BD Knit Design Ltd(New)

Sharitpur, National University, Gazipur
(23.965860N, 90.368274E)
4th September, 2016

Analysis 3D view

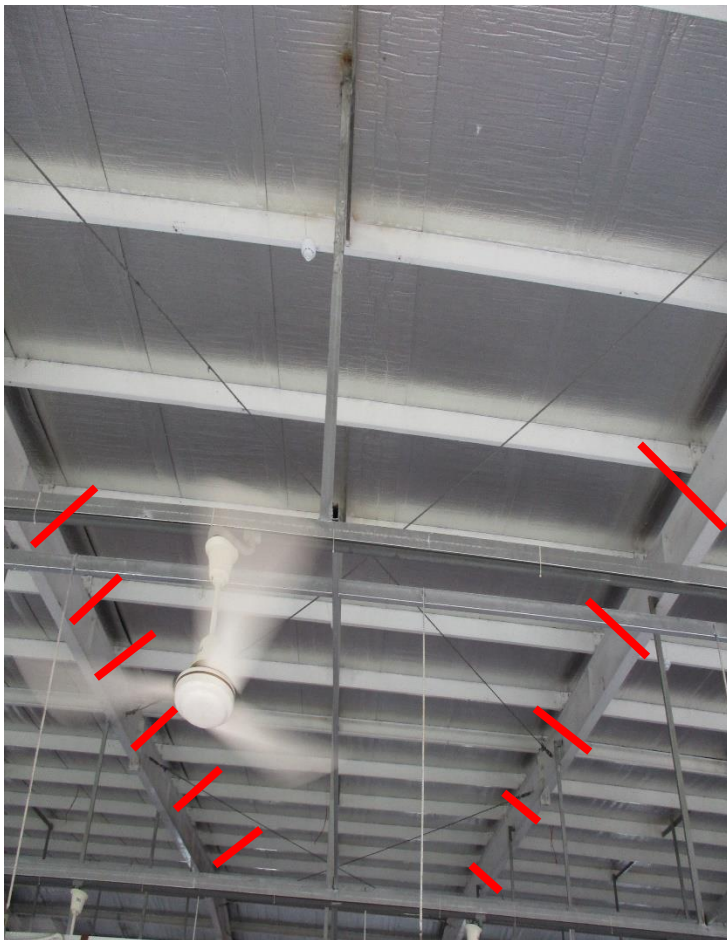
Missing compression strut at end bays

Analysis 3D view image which was found in a document review does not match with on site condition.

Bracing substantially away from supports. End part of the bracing connected to mid height of the column.

There are significant eccentricities of bracing connections may causing minor axis bending to portal frame members. Compression flange braces required for rafters at braced bays also not provided.

Missing compression flange braces

Plan bracing substantially away from vertical supports

Significant eccentricity to plan bracings

Item No.	Observation	Recommended Action Plan	Recommended Timeline
1	Overall stability of the structure	Building Engineer to review bracing system for lateral wind loading as per BNBC with consideration for minor axis bending of rafters due to eccentricity of members at node points. Review design of rafter considering compression flange restraint	6-weeks
2	Overall stability of the structure	Building Engineer to design and detail structural upgrading work where necessary to ensure adequate stiffness of bracing system.	6-weeks
3	Overall stability of the structure	Where required, remedial measures to steelwork to be carried out.	6-months
4	Loose cable bracing	Existing cables in braced bays to be tightened	6-weeks
5	Missing bolts and defected shear clip connection observed	Building Engineer to identify all the omissions and supervise remedial works to the missing bolts in the connections and defective shear clip	6-weeks

**Missing bolts and defected shear clip
connection observed.**

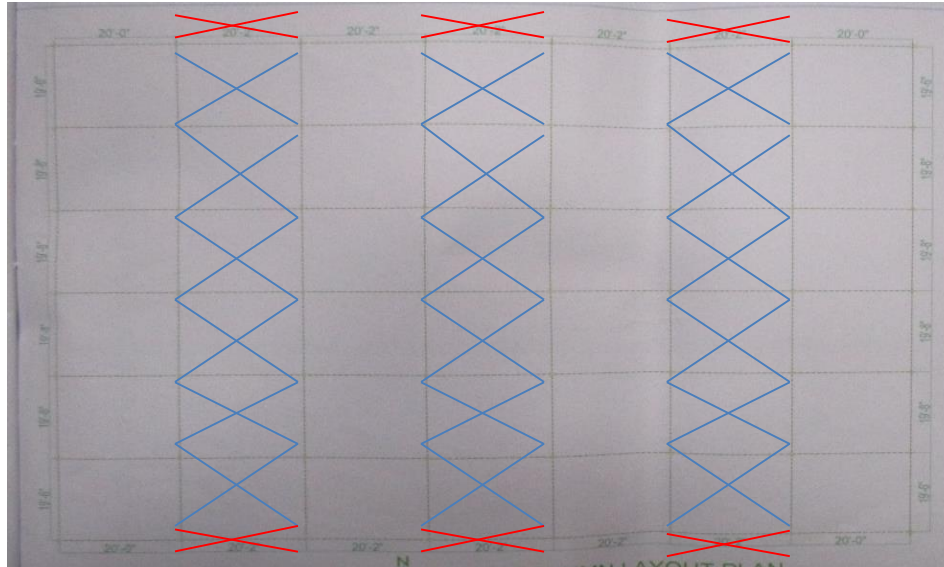
Loose cable bracing

Lose cable bracing was observed on site.

Defected shear clip in critical shear path at bolted connection was observed.

Bolt missing was observed in connection of rafter to rafter and beam to beam connection.

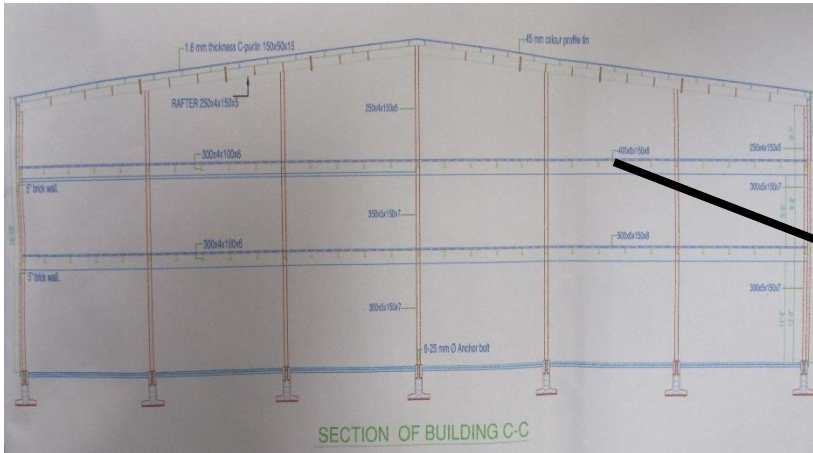
Both horizontal & vertical bracings at 2nd, 4th and 6th bay not shown in drawing.

On site secondary beam depth on mezzanine floor found 250mm, however drawing shows 300 mm.

6	Discrepancies between drawings & on-site observations	Engage a Building Engineer to survey the structure and prepare a full set of "as-constructed" drawings	6-weeks

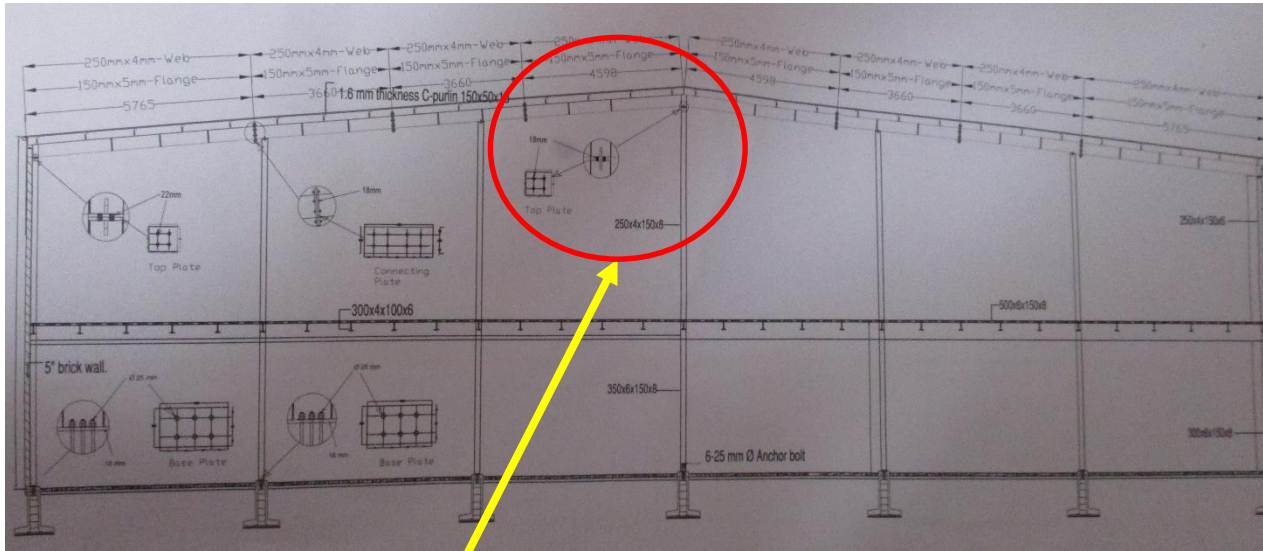
On drawing shows rafter-column joints at ridge are bottom connection, however several side connection have observed on site.

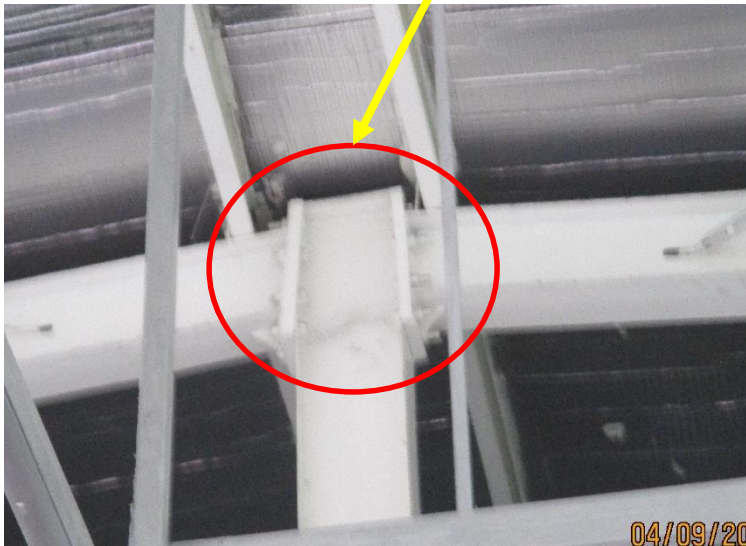
Undocumented water tanks above masonry toilet block.

Adequacy required to be check for the extra Steel column and connection of Stair

The load path and connection of the stair is unclear. Factory engineer requires to be checked the adequacy of stair.

Extra steel column support steel stair

Item No.	Observation	Recommended Action Plan	Recommended Timeline
7	Adequacy required to be check for the extra Steel column and connection of Stair	Factory engineer to review design, loads, columns stresses and check the steel connections adequacy.	6-weeks
8	Adequacy required to be check for the extra Steel column and connection of Stair	Carry out remedial works where required.	6-months
9	Non-engineered steel roof at utility shed and fire scape steel stair	Engage a Building Engineer to check the capacity of the lightweight steel roof structure/connection details and wall/connection details for both utility shed and fire scape steel stair.	6-weeks
10	Non-engineered steel roof at utility shed and fire scape steel stair	Make any necessary alterations as required.	6-months

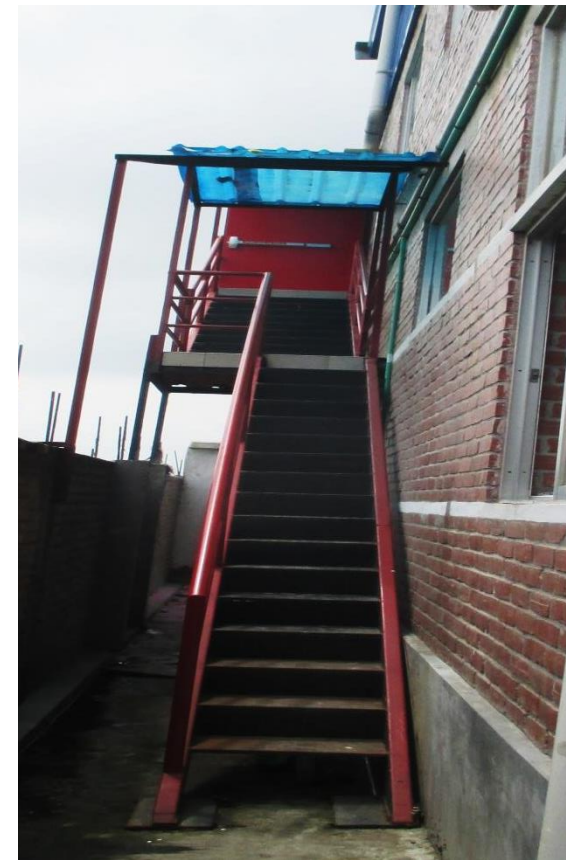
Non-engineered steel roof at utility shed and fire scape steel stair

Poor connection between brick wall and steel roof.

The steel stair supported on 50mm X 50mm angle with poor connection. The steel connection and structural member required to be checked against vertical and lateral load.

Non engineered steel roof of utility shed required to be checked against wind load.
